COUNCIL ASSESSMENT REPORT
NORTHERN REGIONAL PLANNING PANEL

PANEL REFERENCE & DA NUMBER	PPSNTH-420 – DA10.2025.156.1
PROPOSAL	Mixed use development comprising on-grade parking, commercial premises, pocket park and back of house facilities on the ground level; 37 shop top housing apartments, a landscaped podium, a swimming pool and resident amenities on level 1 and 41 shop top housing apartments on level 2 and subdivision of Penny Lane from Lot 1 DP271119 for integration with Lot 14 DP271119
ADDRESS	Lot 1 DP 271119, No. 5 Penny Lane, Byron Bay. Lot 14 DP 271119, No. 5 Penny Lane, Byron Bay.
APPLICANT	Planners North
OWNER	Bayshore Development Pty Ltd Community Association DP271119
DA LODGEMENT DATE	27 May 2025
APPLICATION TYPE	Integrated Development Application – Section 100B Rural Fires Act 1997
REGIONALLY SIGNIFICANT CRITERIA	Section 2.19(1) and Clause 2 of Schedule 6 of State Environmental Planning Policy (Planning Systems) 2021 declares the proposal regionally significant development as it has an estimated development cost exceeding \$30 million.

<p>25. EPASWMM Modelling and Catchment Layout Plan, by Ardill Payne and Partners, original issue, dated 3 October 2025.</p> <p>26. Sto

Figure 17: Section of landscape mounding strategy.

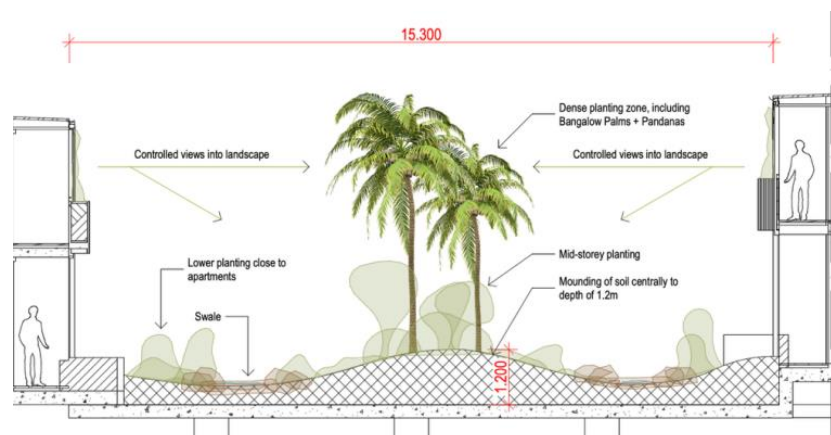
The plans initially submitted with the application indicated max. soil depths of approx. 540mm in the central podium which is insufficient to support the types of trees and shrubs shown in the landscape concept plan including Bangalow and Pandanus palms.

A more detailed section was later provided as part of the applicant's RFI response (refer to **Figure 17**) which demonstrates that soil will be mounded to a depth of 1,200mm in the centre of the podium.

Council's Development Engineer has advised that the placement of mounded soil in the centre of the podium would direct and concentrate stormwater flows into two swale-type areas on either side of the mound. This altered flow regime would change the intended function of the stormwater system in a manner not contemplated by the MUSIC and DRAINS modelling submitted with the application.

Figure 20: SE Elevation showing the building extending across Lot 1 and Lot 14 in DP 271119.

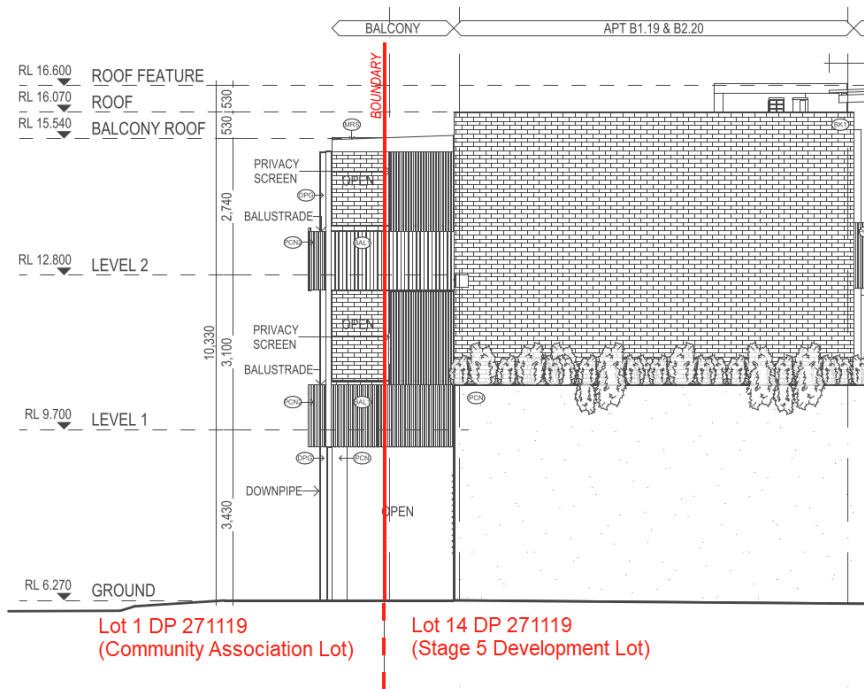
Clause 4.5 does not differentiate between Torrens title, community title, or strata title for the purpose of calculating site area. Consequently, where land is subdivided under multiple title systems, the area of each relevant lot—whether Torrens, community, or strata—must be considered individually when determining the site area and assessing compliance with the applicable FSR standard.

The Habitat precinct is situated on a single Torrens title parcel, legally described as Lot 3 in DP 1004514, with a total area of 4.921 hectares. A community title scheme also applies to the site, creating a number of development lots corresponding to individual stages of the Habitat project. The proposed Stage 5 building spans two of these community title lots—Lots 1 and 14 in DP 271119—which have areas of 20,157 m² and 6,615 m² respectively. As the development physically occupies both lots, their areas must be considered cumulatively when determining the applicable site area and calculating the floor space ratio.

Figure 21: Section B–B (Easy Block) with the height exceedance highlighted in yellow.

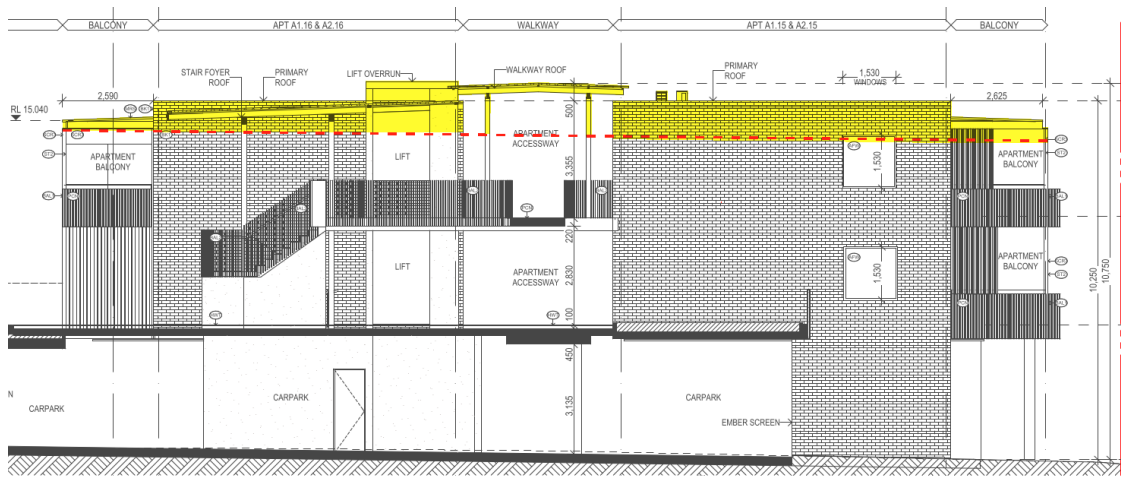
The applicant states that the proposed development has a maximum height of 10.48m above existing ground level and exceeds the height limit by 1.48m or 16.4% of the development standard. The applicant refers to Point K (lift overrun) on the attached height plan as the highest point on the building requiring consideration.

The main body of the development varies between 9.71m and 10.3m in height, with an average height exceedance of approximately 10.1m or 15% of the development standard.

Additionally, two walkway roof structures are proposed for each block, which reach a height of 10.6m and 10.8m respectively. The walkway roof structure on the Easy Block exceeds the maximum height standard by approx. 20% at the highest point (point N on the height plan). The applicant asserts that this structure is an architectural roof feature (Clause 5.6 of LEP 2014) and therefore does not require consideration under the height clause.

Figure 23: Section of the proposed stormwater treatment system.

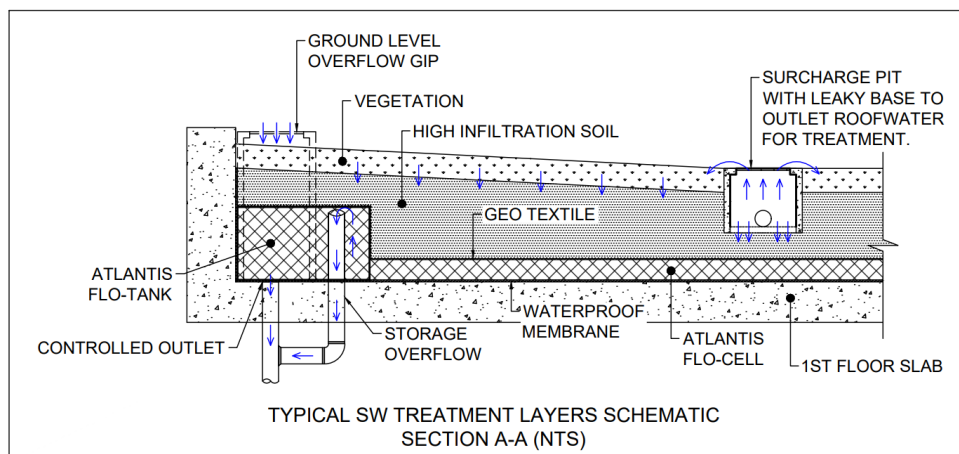
The DRAINS model (a software model used to calculate stormwater conveyance and peak flows) is inconsistent with the design of the stormwater system as depicted on the architectural and civil engineering plans. Specifically, the plans identify the use of 20 x 67mm outlets for the Atlantis Flo-Cell system, and 20 x 102mm outlets for the Atlantis Flo-Tank system. However, the DRAINS model relies on a “Sag Inlet” spreadsheet

The system has not been designed to provide extended detention, and the soil depths are insufficient to provide effective stormwater treatment. While additional soil depths were later proposed by the applicant to support the types of trees and mature vegetation specified in the landscaping plan, these additional soil depths have not been incorporated into the stormwater model leading to uncertainty over the system function and model reliability.

There is a conflict with the landscape plan and the stormwater plan. The landscaping concept involves placing a range of mature trees, mid-storey shrubs and grasses on the podium to assist in the provision of privacy between apartments and to enhance residential amenity.

Proposed plant species include Bangalow and Pandanus palms, Elephant's ear, Native ginger, Pig's face, and Lomandra. The root systems of these species will likely extend into the soil layer and the underlying Atlantis Flo-Cells, potentially damaging and impacting the hydraulic performance of the system. The stormwater model does not appear to have accounted for the presence of mature vegetation on the podium with root systems extending into the filter media, nor has it accounted for the additional mounded soil profiles (up to 1.2m in depth) that will be needed to support the types of vegetation specified in the landscaping plan.
